ADDENDUM #7

Snowden Admin Building Mechanical Upgrades Project No. ANC-C-23-0001

Date: December 2, 2022

1 ENLARGED BOILER ROOM PLAN
M301 Scale: 1/2" = 1'-0"

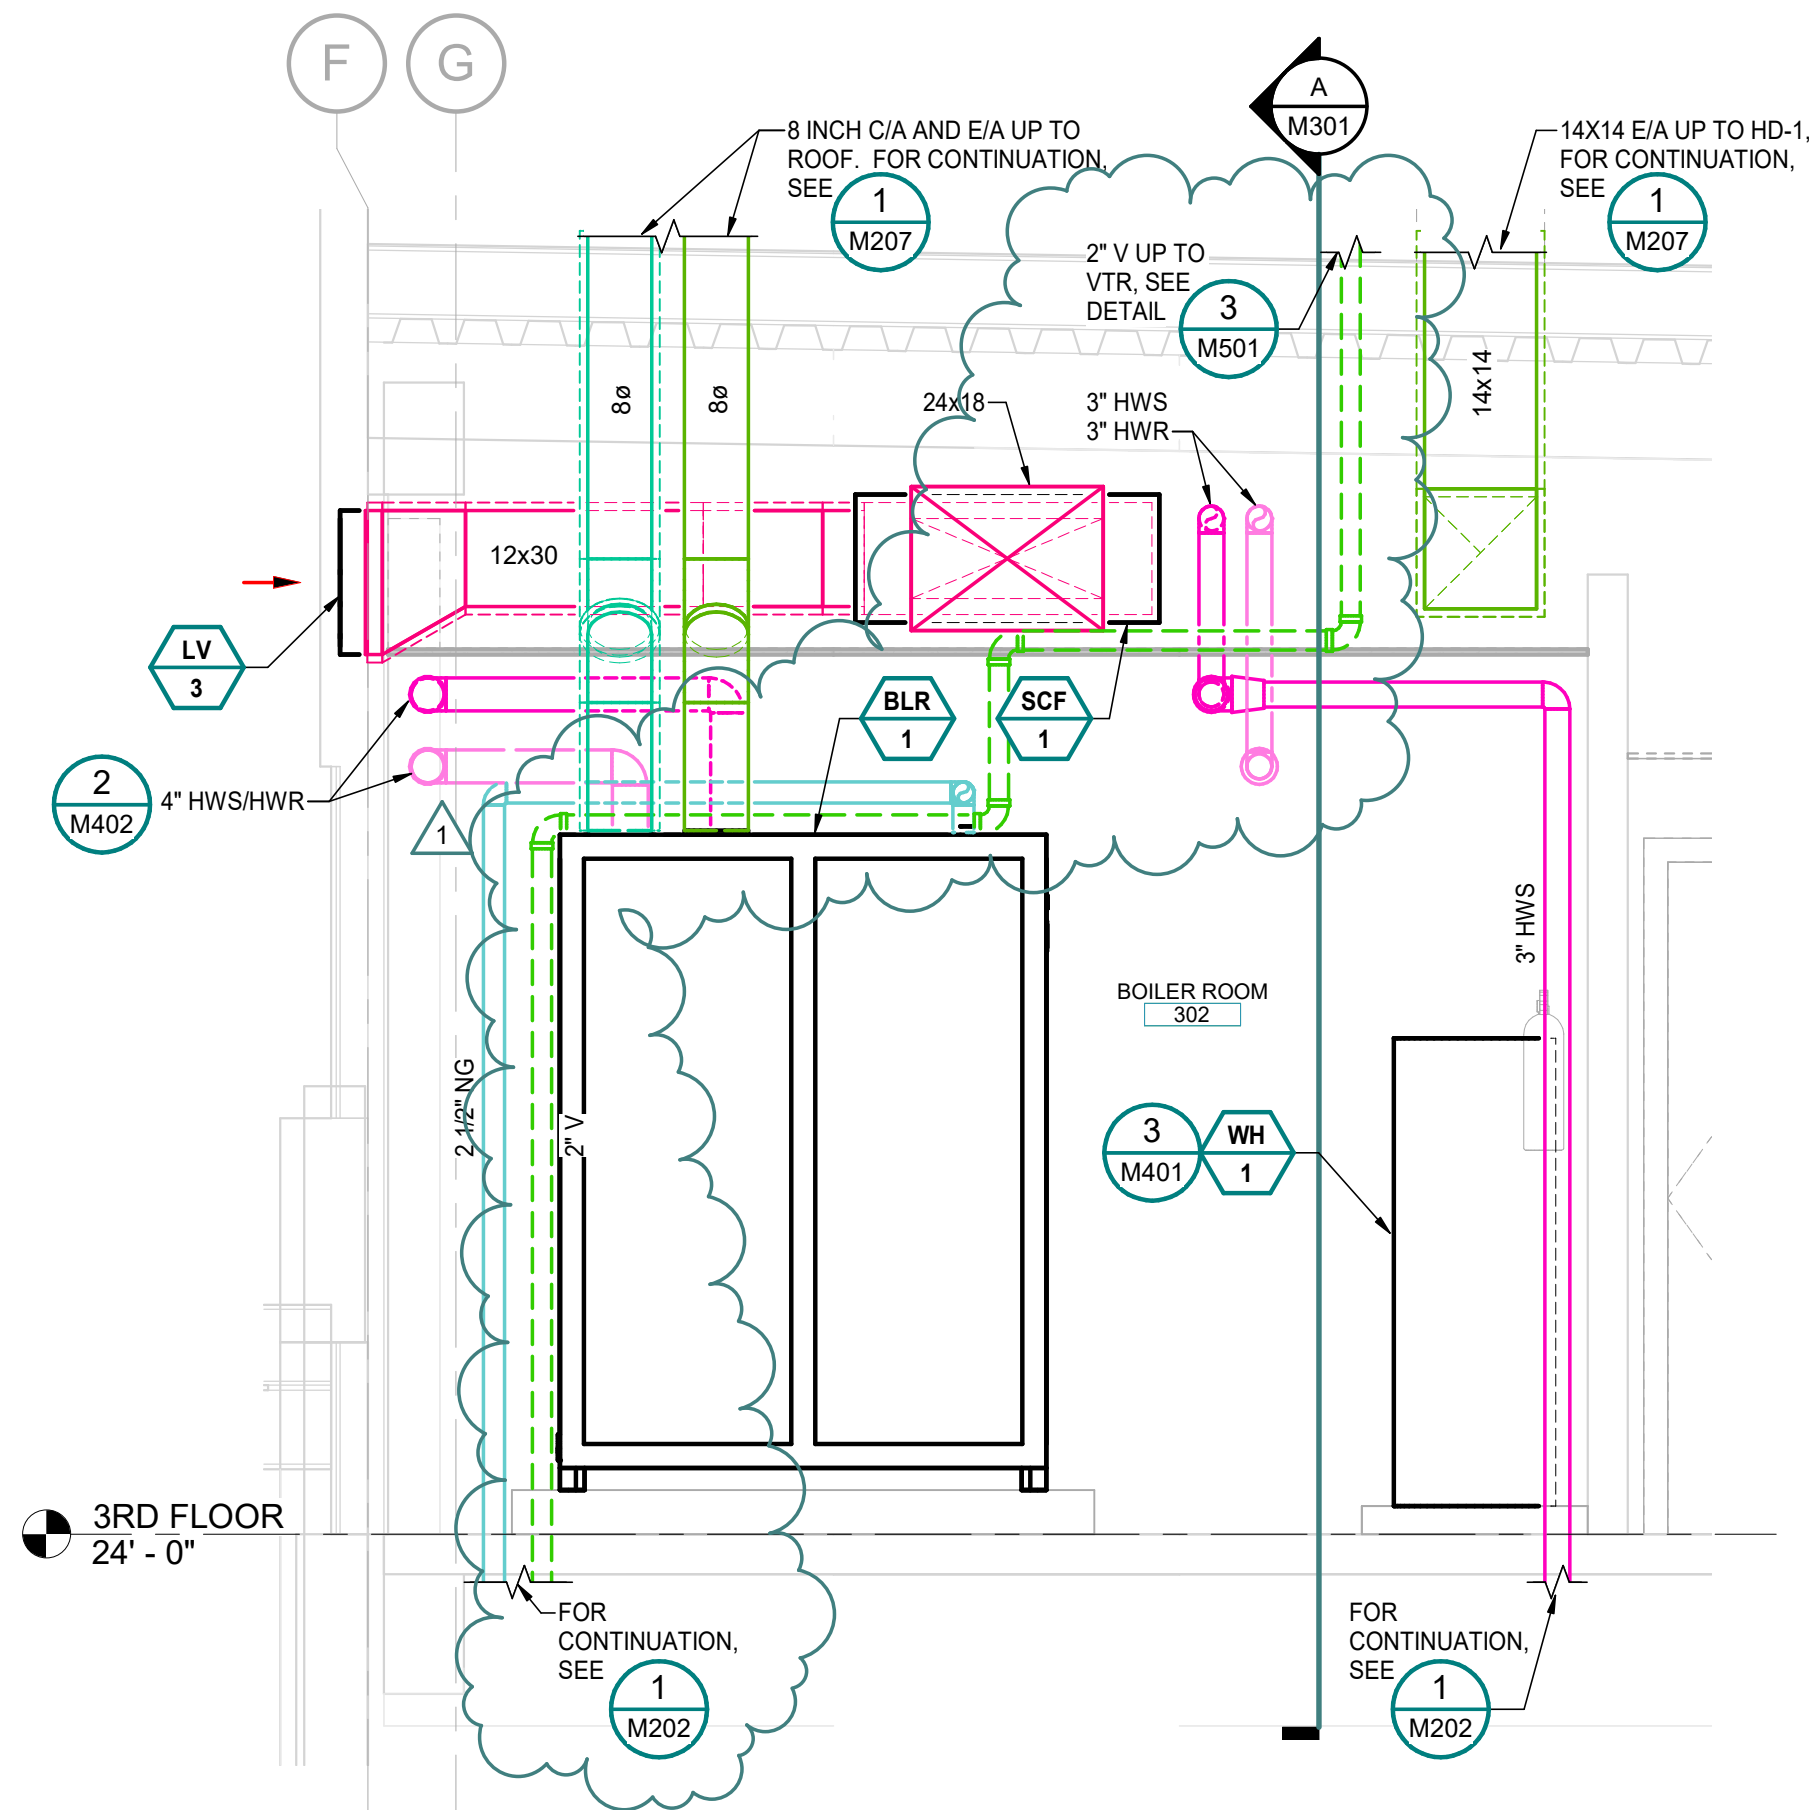
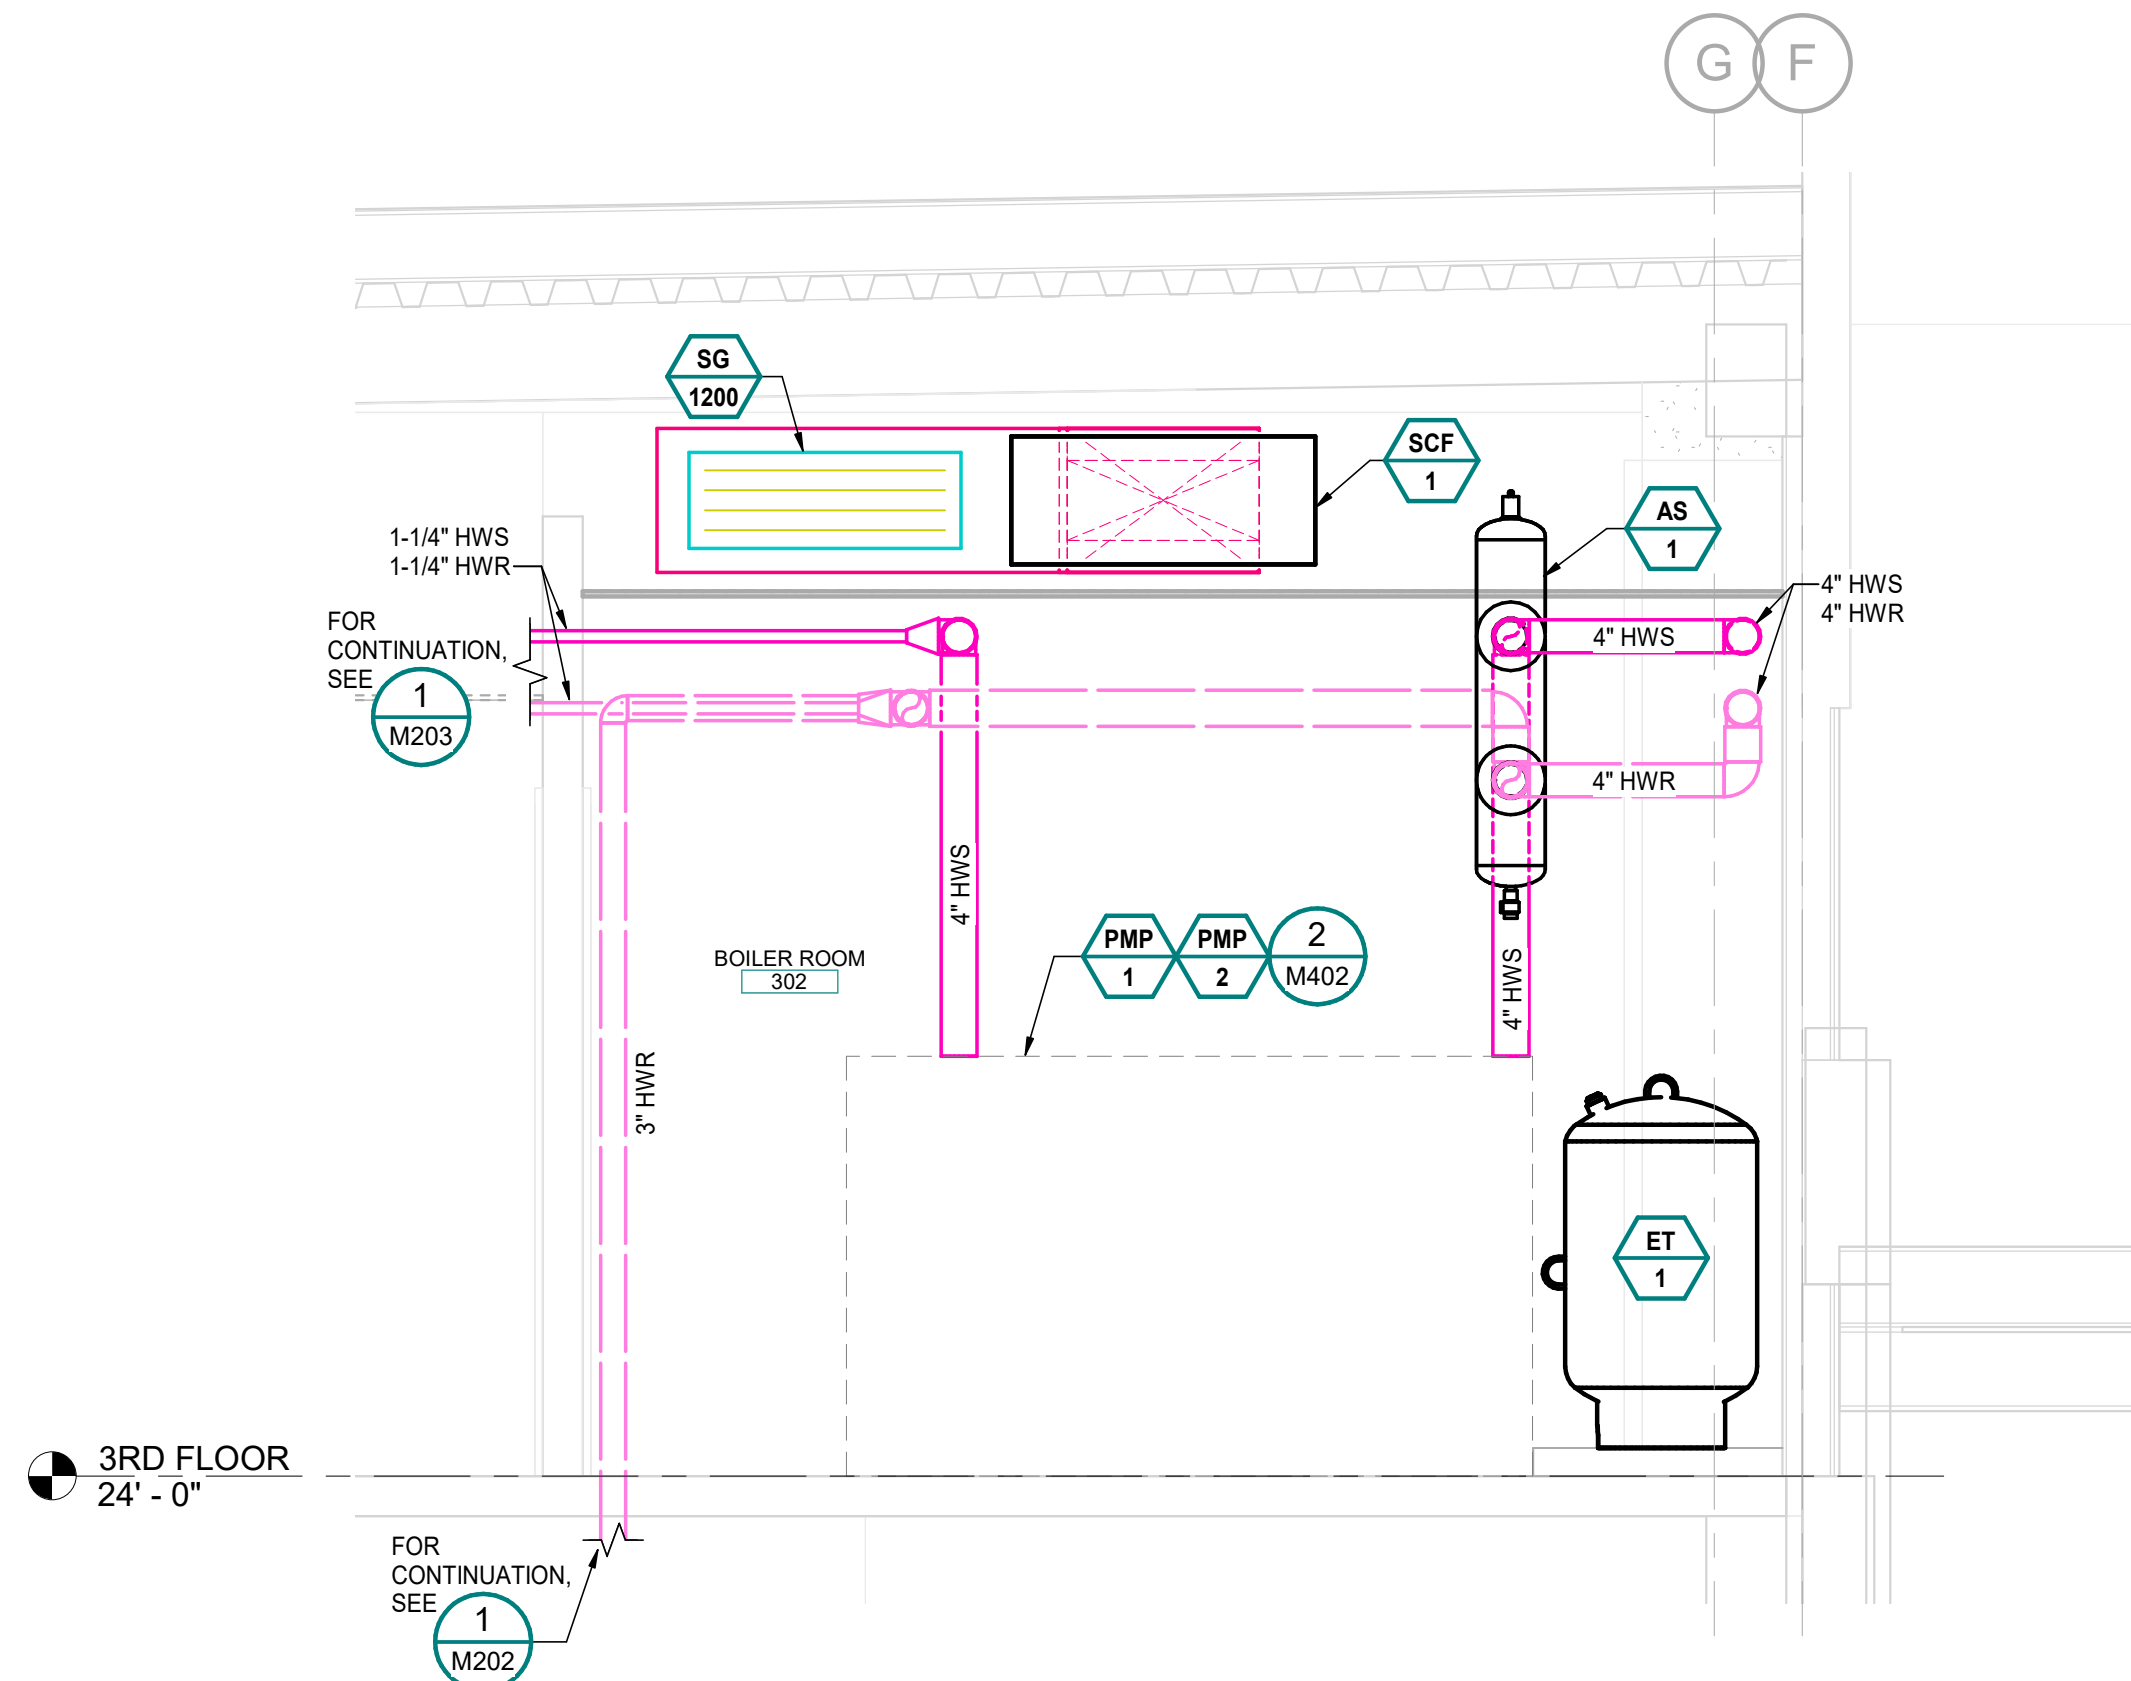
- a. ADD hydronic system isolation valves as indicated on reissued drawings M201 and M202.
- b. DEMOLISH existing floor drain and PROVIDE new floor drain, FD-1, as indicated on reissued drawings M108 and M303.
- c. ADD sheet note #4, vent piping, and VTR, for new floor drain, FD-1, connection clarification as indicated on reissued drawing M301.

1. Drawing M-108 shows an existing floor drain that is to remain. Detail 1 on M-301 shows a FD-1 floor drain being installed in the same location. Is there a new drain required as shown on M-301 or does the existing drain remain as shown on M108?

2. Detail 1 on M-301 shows a new FD-1 floor drain being installed. There is nothing shown clarifying where this drain is to be connected. Please advise.

AMC Response: The fan room floor drain is to be demolished and replaced, see reissued drawings M108 and M303. The new boiler room on M301 will have a new floor drain as shown.

AMC Response: See reissued drawing M301 for new floor drain, FD-1, connection clarification.

1. MINIMUM PIPE SIZE IS 3/4". TERMINAL DEVICE BRANCH PIPE IS 3/4", UNLESS OTHERWISE NOTED.
2. PROVIDE MANUAL HIGH POINT VENTS, LOW POINT DRAINS (WITH CAPPED HOSE CONNECTIONS), AND SLOPE PIPING TO ALLOW FOR COMPLETE DRAINAGE OF THE HYDRONIC SYSTEM.
3. FOR TYPICAL PIPE AND DUCT PENETRATION, SEE DETAIL 1/M506.
4. FIELD ROUTE AND CONNECT FLOOR DRAIN WASTE PIPING TO DWV/E PIPING IN CEILING BELOW. CONNECT P-TRAP TO TRAP PRIMER TP-1 IN BOILER ROOM 302. FIELD ROUTE VENT PIPING IN BOILER ROOM AND PROVIDE NEW VTR, SEE DETAIL 3/M501.
